**CITY OF KELOWNA
MEMORANDUM**

APPLICATION NO. OCP06-0023, Z06-0066 **OWNER:** Church of God

AT: 515 Gerstmar Rd. **APPLICANT:** Harvey Benson

PURPOSE: TO AMEND THE OFFICIAL COMMUNITY PLAN FUTURE LAND USE DESIGNATION OF THE PROPERTY FROM THE EDUCATION / INSTITUTIONAL DESIGNATION TO THE LOW DENSITY MULTIPLE DWELLING DESIGNATION.

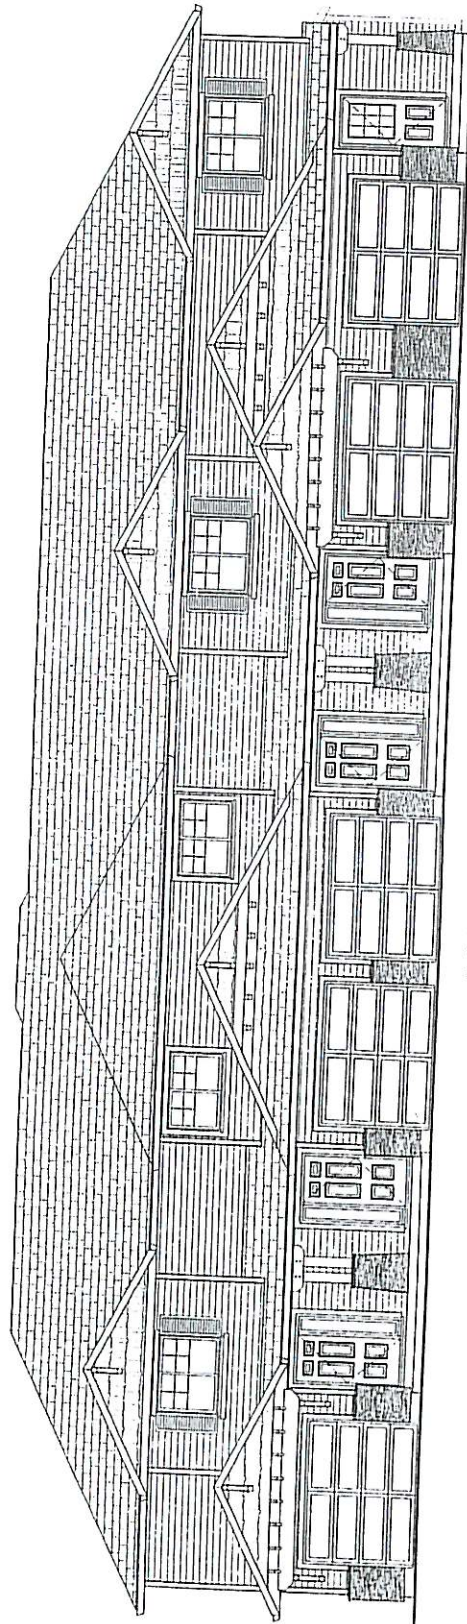
Fire department access, fire flows and hydrants as per the BC Building Code and City of Kelowna Subdivision Bylaw. Engineered fire flows should determine hydrant requirements. Note: If road access is over 90M and dead ends, a fire truck turnaround is needed.

Identify handicap parking stall(s), no floor plan layouts for preliminary code check on units. Site layout appears ok otherwise.
